MODEL:	TYPE:	SECTION/GROUP:	DATE:
<b>J Series</b>	<b>Field Change Program</b>	<b>07- Electrical</b>	<b>12/07/2018</b>

Motor Coach Industries ("MCI") has become aware that on MY2018 J4500 coaches, the potential exists for water intrusion into the remote junction boxes, potentially causing corrosion and possible failure of the electrical connections.

### 3.2 Installing the rear connector gasket

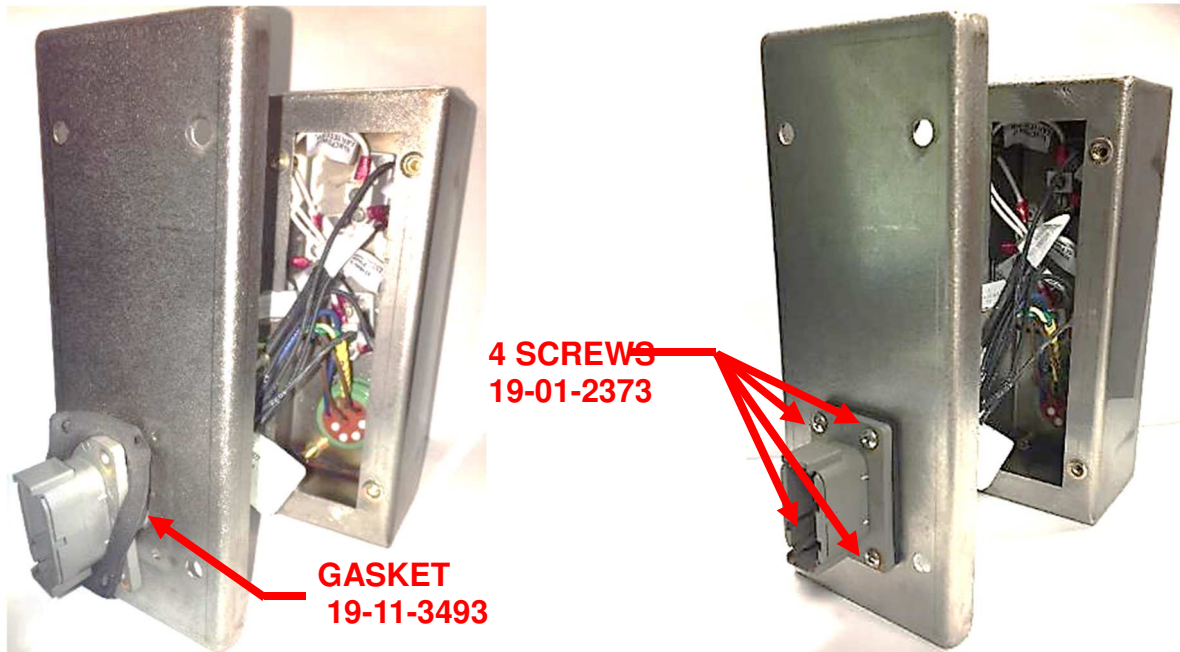
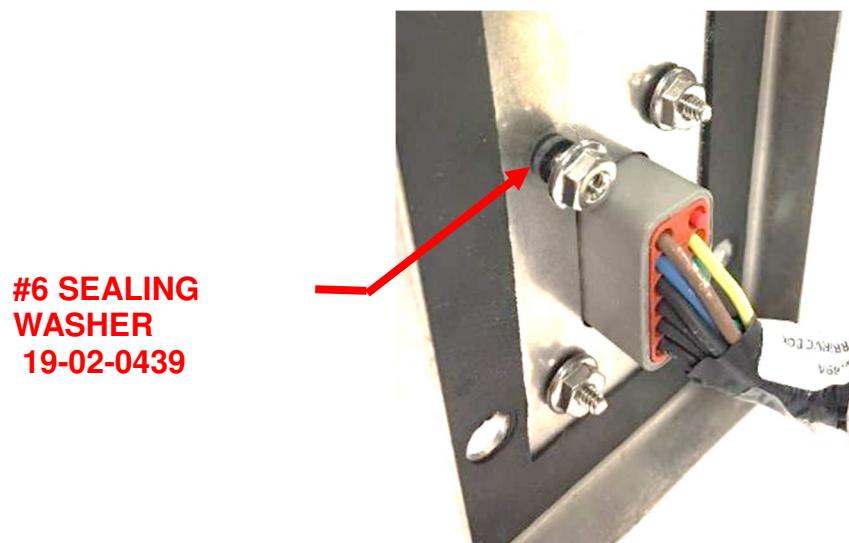
Stretch the Deutsch gasket 19-11-3493 (VPN DT12-L012-GKT) over the connector, taking care not to tear the gasket. Push the connector and gasket against the cover, then install the four new stainless steel screws 19-01-2373 to secure the connector.

Install the #6 sealing washer 19-02-0439 onto the stainless steel screws. Then reinstall the existing locknuts onto the stainless steel screws.

### 3.4 Installing the front connector gasket

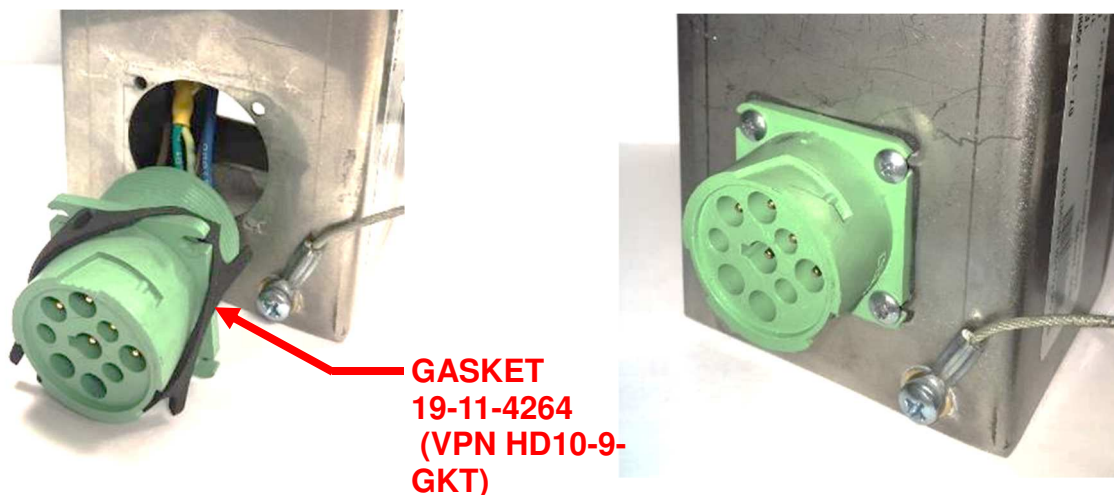
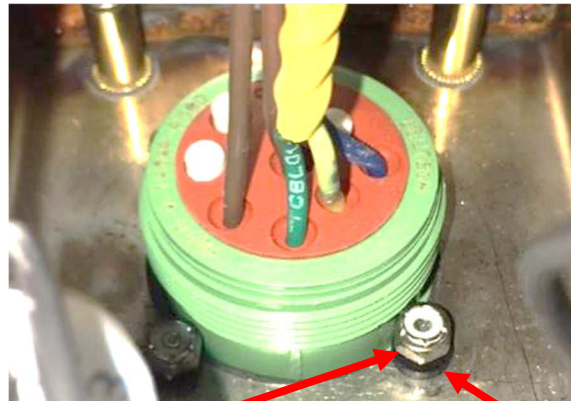
Stretch the Deutsch gasket 19-11-4264 (VPN HD10-9-GKT) over the connector, taking care not to tear the gasket. Press the connector and gasket against the cover. Then reinstall the four screws.

Install the #6 sealing washer 19-02-0439 onto the original screws and reinstall the four original lock nuts. Use a screwdriver or similar rod with a small diameter to help guide the washer onto the screw.

**#6 SEALING  
WASHER 19-02-0439**

### 3.5 Installing the switch sealing washers

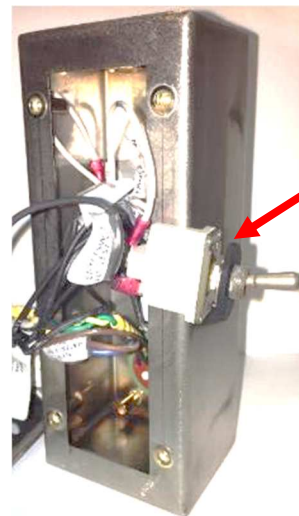
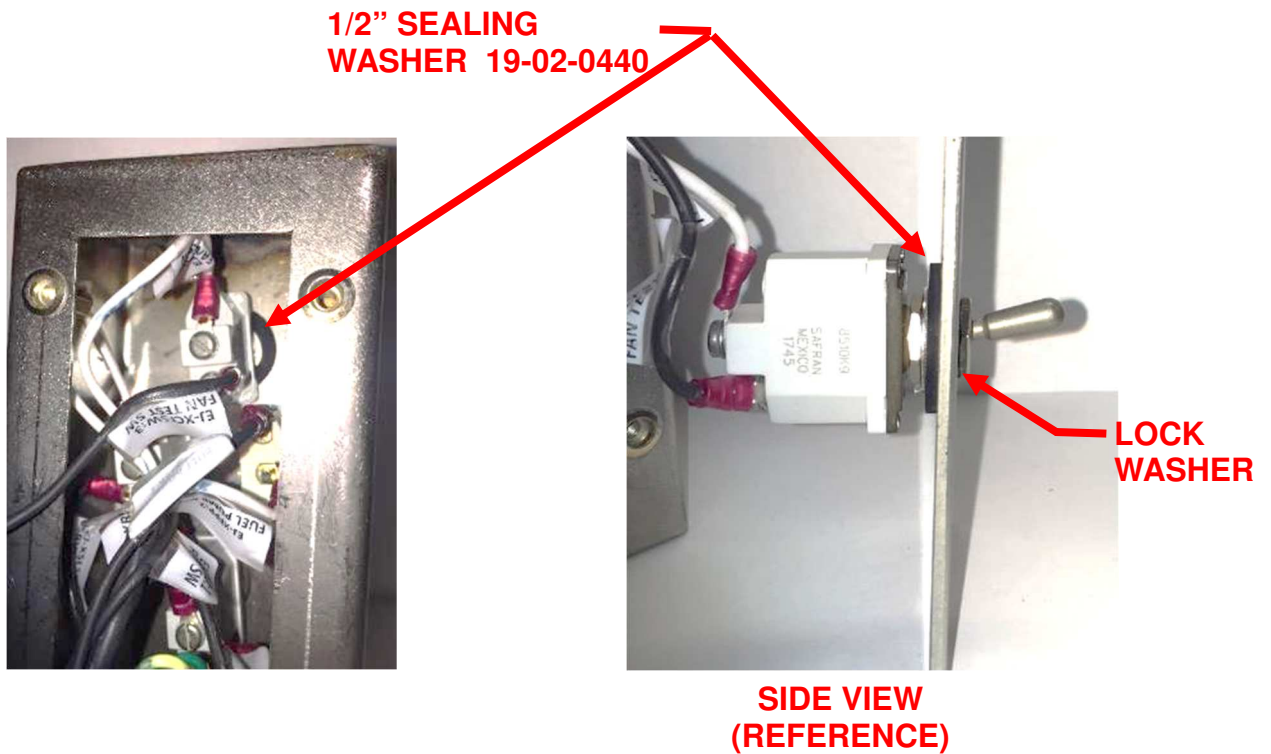
Remove one nut and lock washer from one of the four switches. Then remove a switch and insert a 1/2" sealing washer 19-02-0440 onto the shaft.

**1/2" SEALING  
WASHER 19-02-0440**

### 3.6 Installing the “Duckbill”

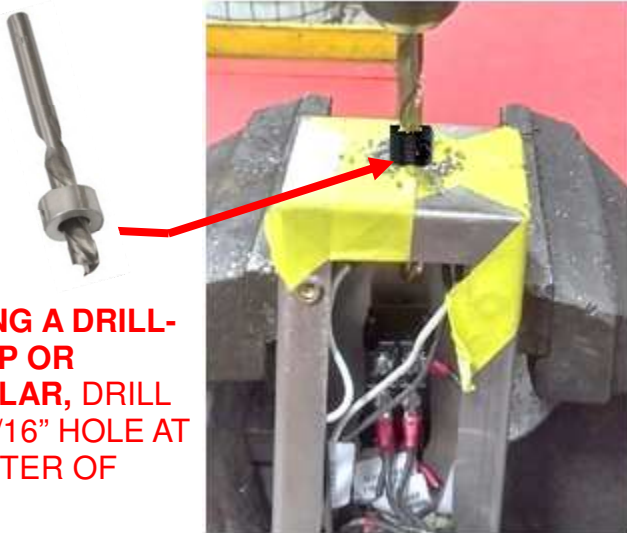
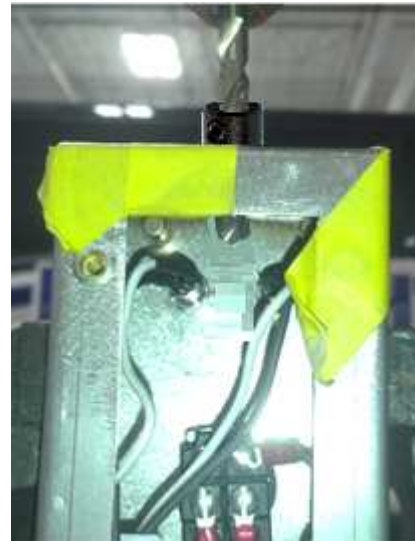
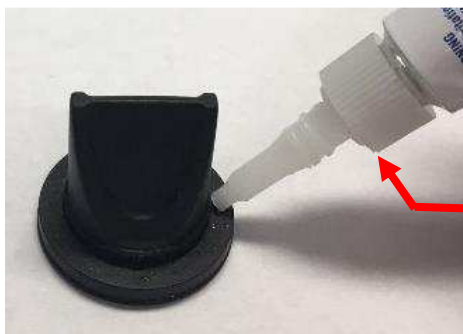
Drill an 11/16” hole in the bottom center of the box making sure to avoid the LED lamp and wires by using a drill-stopper, pipe or similar.

**USING A DRILL-STOP OR SIMILAR, DRILL A 11/16” HOLE AT CENTER OF BOX**

Add cement adhesive 23-02-0123 (or equivalent) to bottom flange on the duckbill 19-05-0425. Then install duckbill 19-05-0425 inside box and allow at least 10 minutes to dry.

**APPLY ADHESIVE 23-02-0123**

### 3.6 Installing the box cover

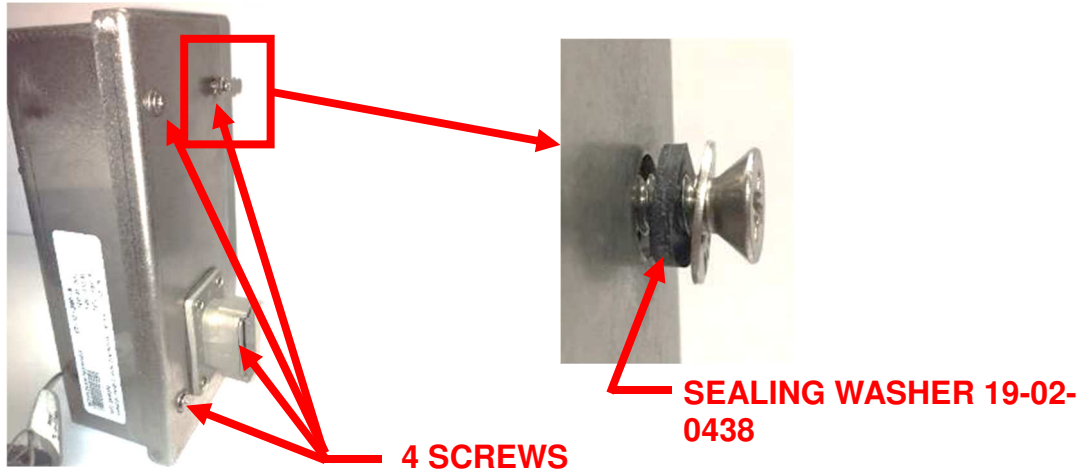
Place the enclosure cover onto the enclosure with the connector at the bottom of the assembly. Assemble #8 sealing washers 19-02-0438 to the four cover screws and insert a screw in each of the holes into the cover.

### 4.3 Installing the rear connector gasket

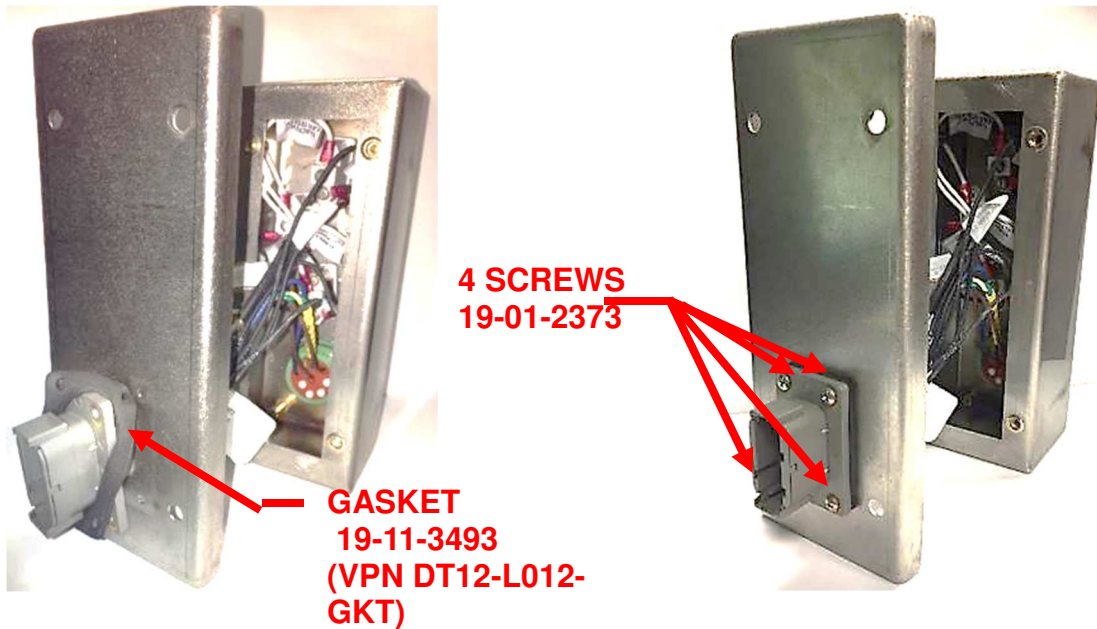
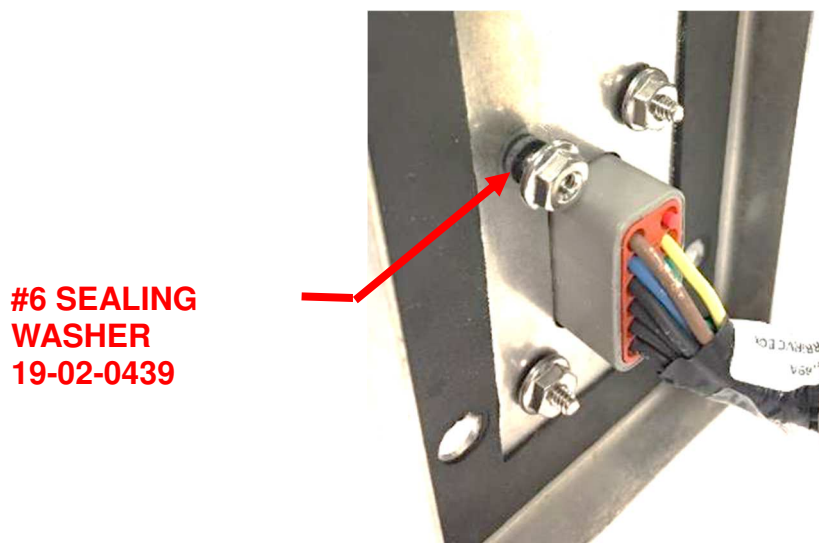
Stretch the Deutsch gasket 19-11-3493 (VPN DT12-L012-GKT) over the connector, taking care not to tear the gasket. Push the connector and gasket against the cover. Then install the four new stainless steel screws 19-01-2373.

Install the #6 sealing washer 19-02-0439 onto the stainless steel screws. Reinstall the existing locknuts onto the stainless steel screws as shown below:

#### 4.4 Installing the 3/8" LED lamp washers

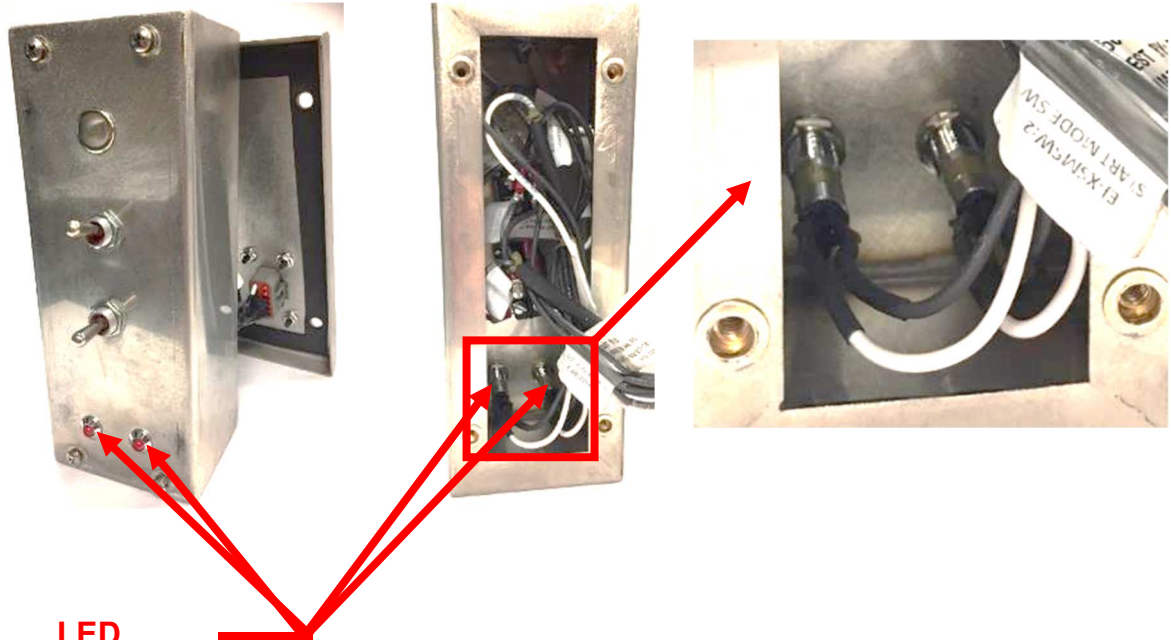
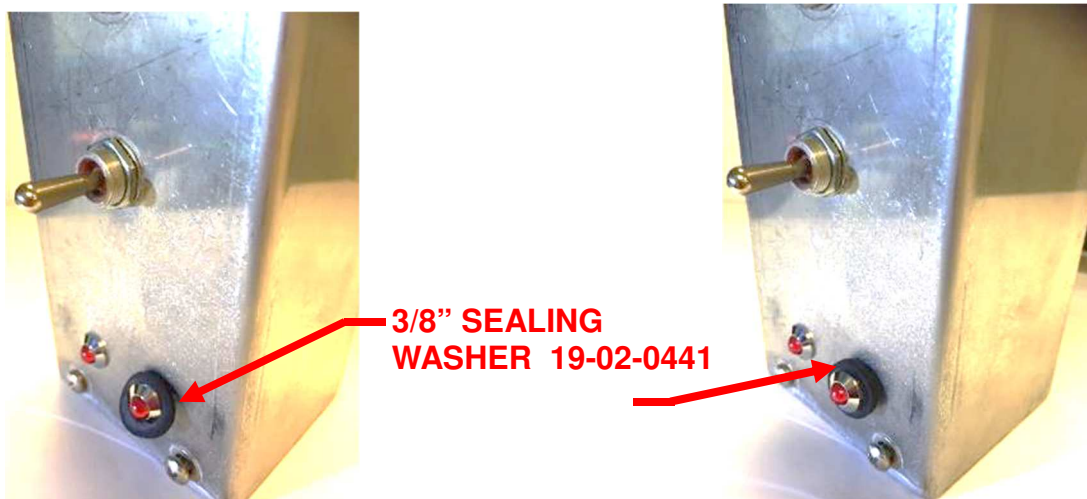
Stretch a 3/8" sealing washer 19-02-0441 over the front of the LED lamp. Then tighten the nut on the back of the LED lamp.

**3/8" SEALING  
WASHER 19-02-0441**

### 4.5 Installing the 1/2" switch sealing washers

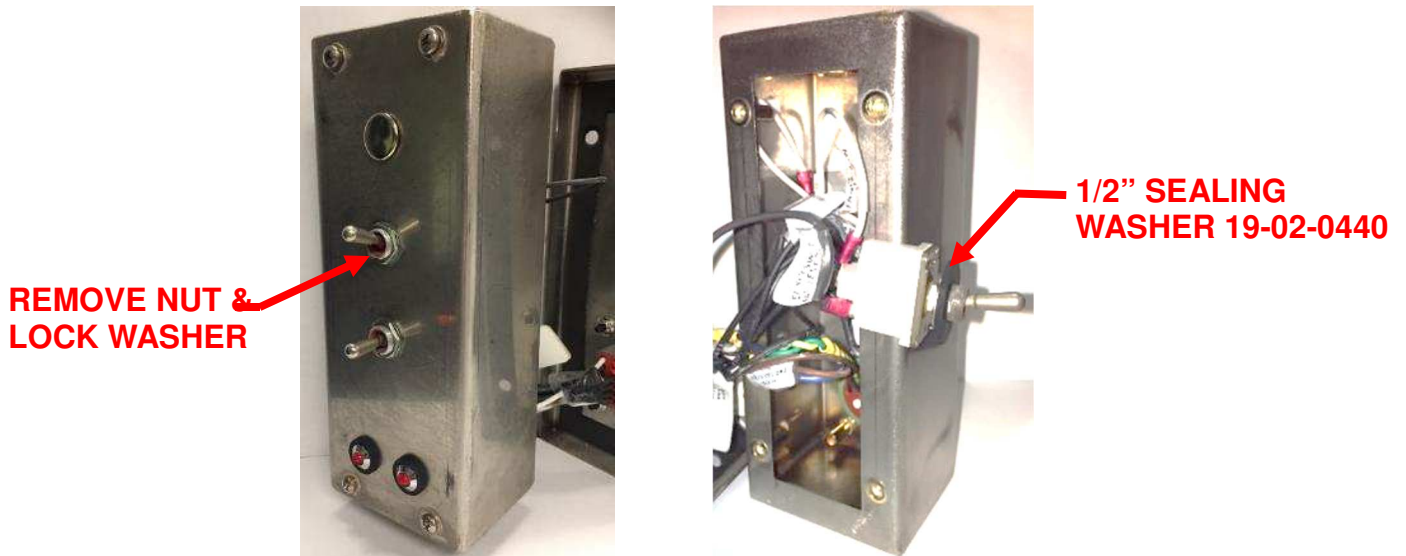
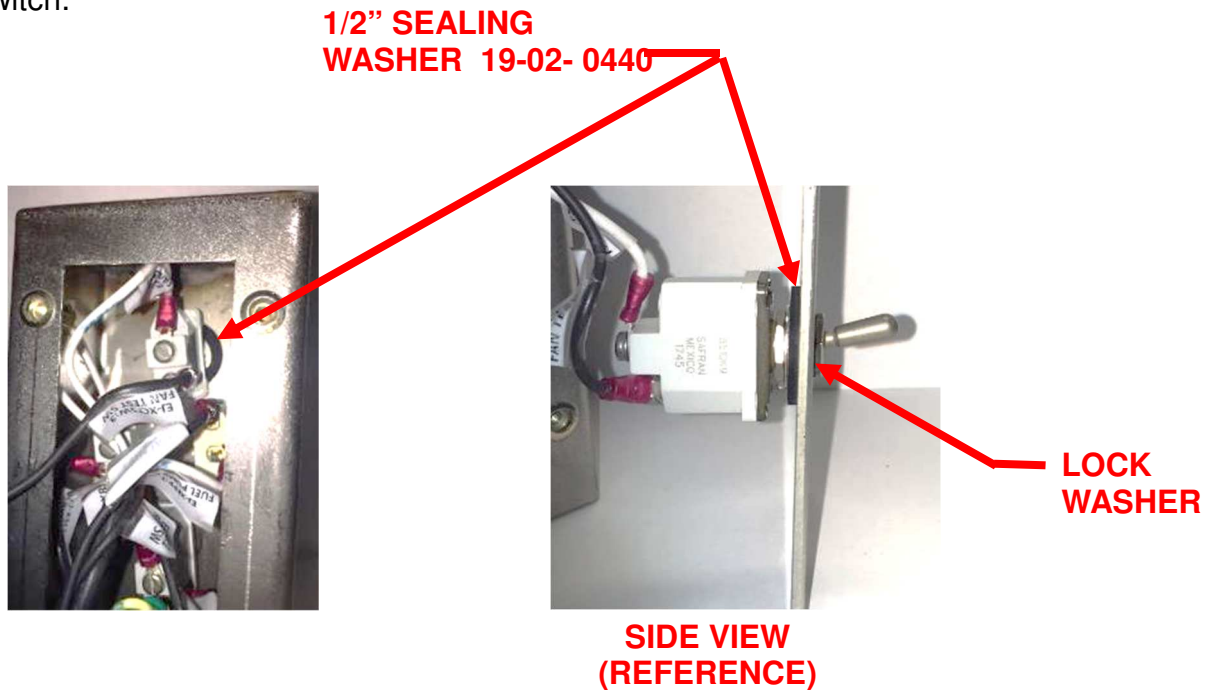
Remove one nut and lock washer from one of the four switches. Then remove the switch and assemble a 1/2" sealing washer 19-02-0440 over the shaft.

#### 4.6 Installing the 1/2" Sealing Plug

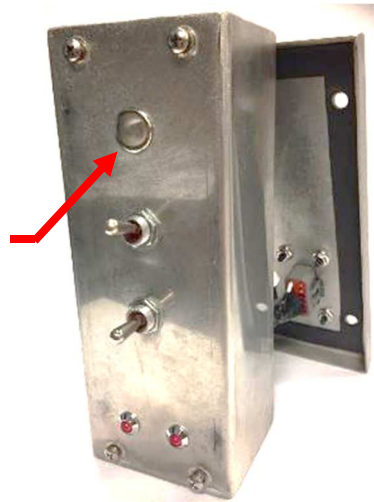
Remove the button plug from the top hole and insert a 1/2" sealing plug 19-08-0001.

**1/2" SEALING  
PLUG 19-08-0143**

#### 4.7 Installing the "Duckbill"

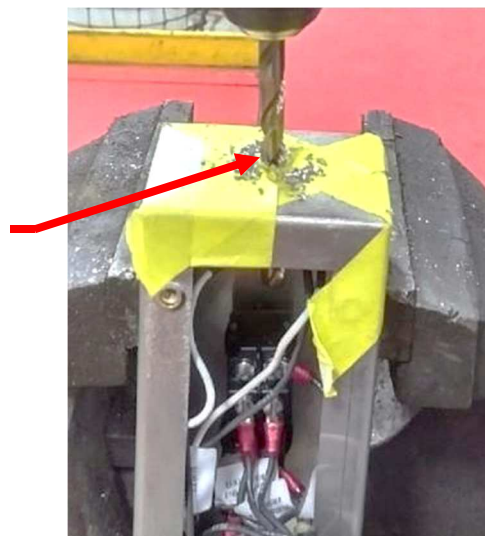
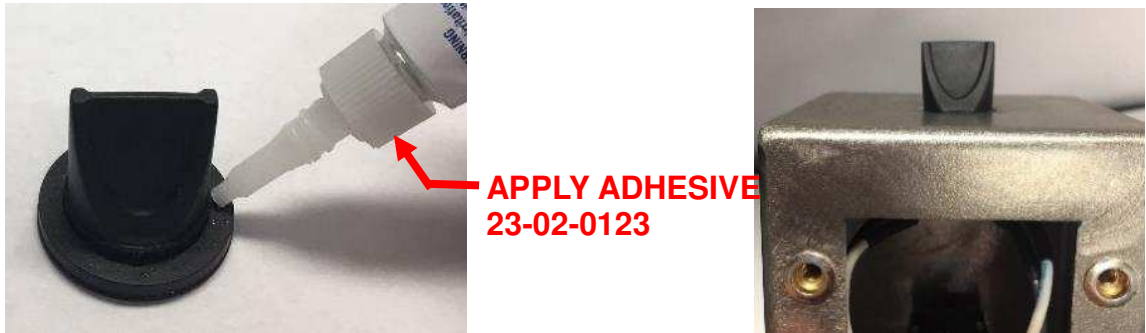
Drill an 11/16" hole in the bottom center of the box making sure to avoid the LED lamp and wires.

**DRILL 11/16"  
HOLE AT  
CENTER OF  
BOX**

Add cement adhesive 23-02-0123 (or equivalent) to bottom flange on the duckbill 19-05-0425. Then install duckbill 19-05-0425 inside box and allow at least 10 minutes to dry.

#### 4.8 Installing the box cover

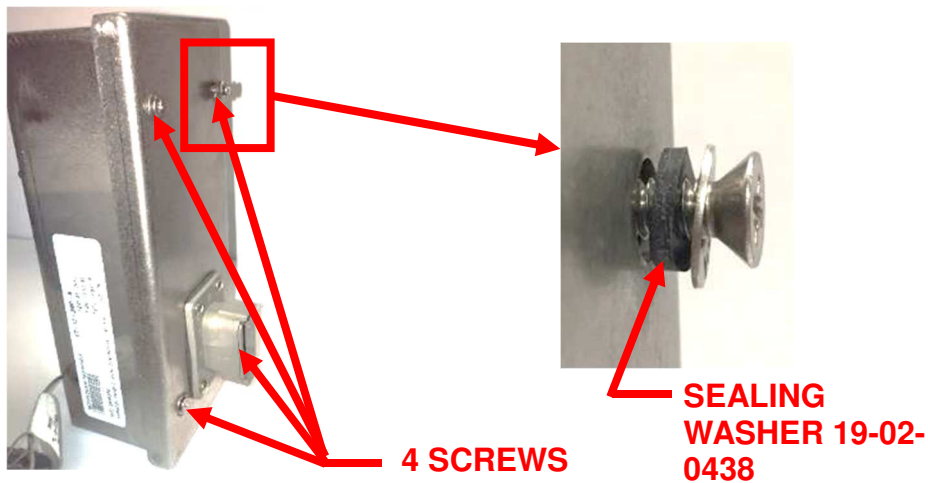
Place the enclosure cover onto the enclosure with the connector at the bottom of the assembly. Then assemble #8 sealing washers 19-02-0438 to the four cover screws and insert a screw in each of the holes into the cover.
